LIGHTNING F MK 3

Addendum A

EJECTION SEAT MK. BSC MOD. NO. 2690

(Introduction of downward pull negative-G restraining strap)

Fig. 1 Arrangement of downward pull negative-G restraining strap in seat pan

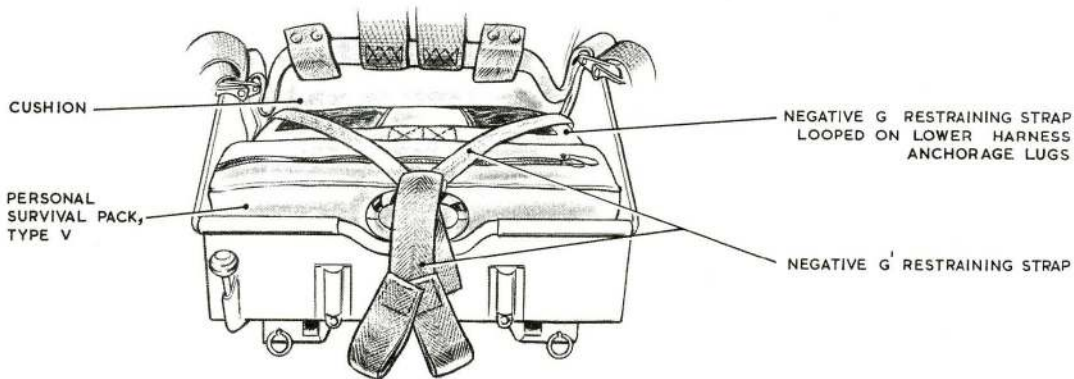
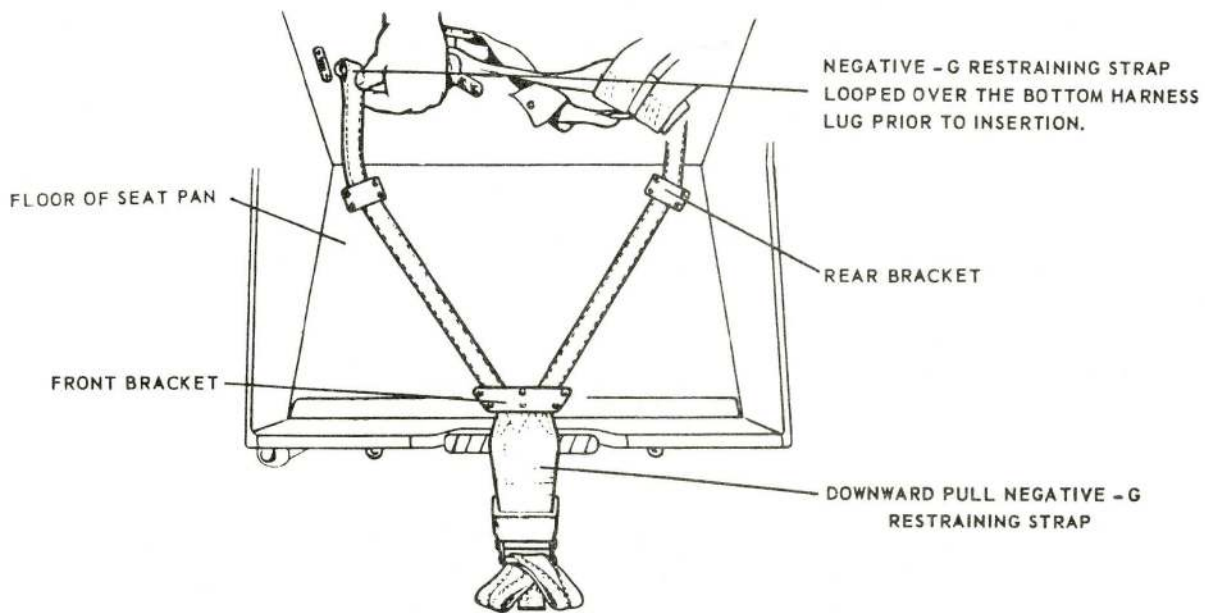
1 Modification E.S. 2690 introduces a downward pull negative-G restraint strap in lieu of the upward pull strap introduced by modification P A.69.

(5) Fig.3. Arrangement of negative-G restraining strap on P.S.P Disregard Fig. 3 in Chapter 4 and refer to Fig. 1 of this addendum.

Housed in the seat pan is a Type V personal survival pack, which with the cushion, forms a comfortable seat for the occupant. The pack is attached to the combined harness by side quick-release couplings and its lowering line is connected to the flying clothing during strapping in. A negative-G restraining strap which is tightened by a downward pull (introduced by modification E.S.2690) is fitted underneath the pack, the strap is passed through brackets attached to the floor of the seat pan and anchored to the rear harness attachment lugs and the lap strap lugs which fit into the harness quick-release box. When tightened, the strap restrains the occupant from vertical movement when subjected to high negative-G forces.

(a) Thread the white straps through the front bracket on the floor of the seat pan from front to rear, ensuring that the yellow tab on the buckle is facing forward. The white straps are marked 'PORT' and 'STAR BOARD' and it is essential that they are so positioned to ensure correct installation.
(b) Pass the straps rearwards and thread each strap through its respective rear bracket in the floor of the seat pan.
(c) Engage the looped end of each strap over its respective bottom lock harness lug and insert the lugs into their respective bottom locks. It may be necessary to partially depress the harness release lever beneath the barostatic time release unit to

(d) Drape the blue 'Y' piece of the negative-G strap OVER THE TOP of the seat pan firing handle

(e) Lift the harness clear of the seat pan and insert the personal survival pack into the pan

Fig. 2 Arrangement of downward pull negative-G restraining strap to lap straps

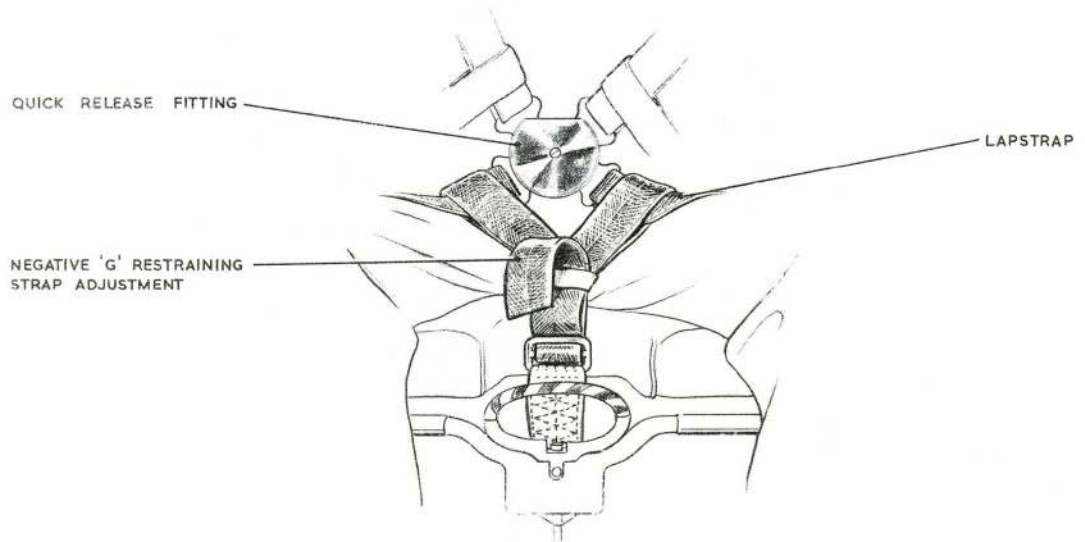
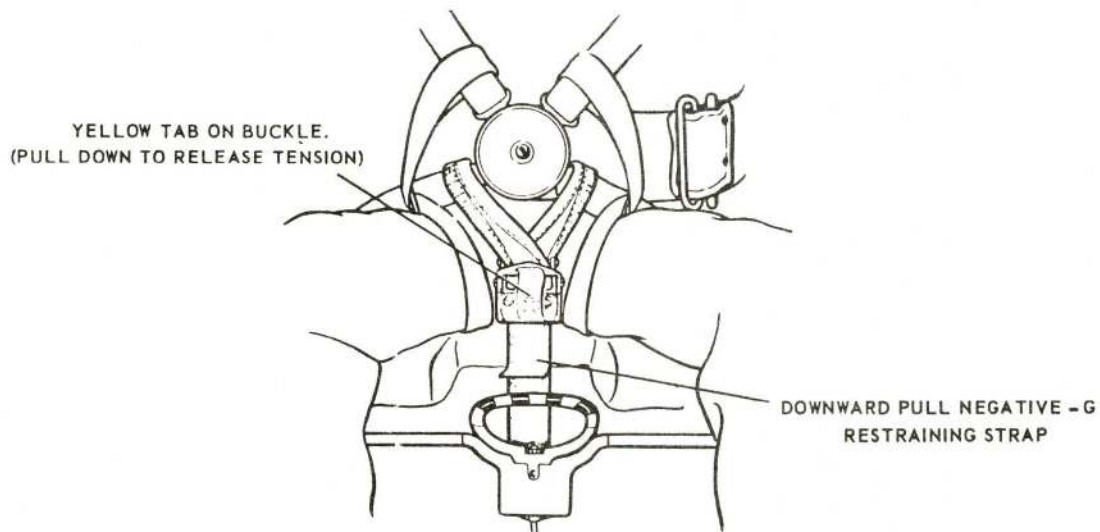
Fig.7 Arrangement of negative-G restraining strap to lap straps. Disregard Fig.7 in Chapter 4 and refer to Fig. 2 of this addendum.

Tighten the negative-G restraint strap by pulling DOWNWARDS on the free end of the blue strap until the strap is as tight as possible and ensure that the free end is then tucked down BEHIND the alternative firing handle. The strap is fitted with a snubber, which is released by pulling downwards on the yellow tab attached to the snubber lever, to loosen the strap.
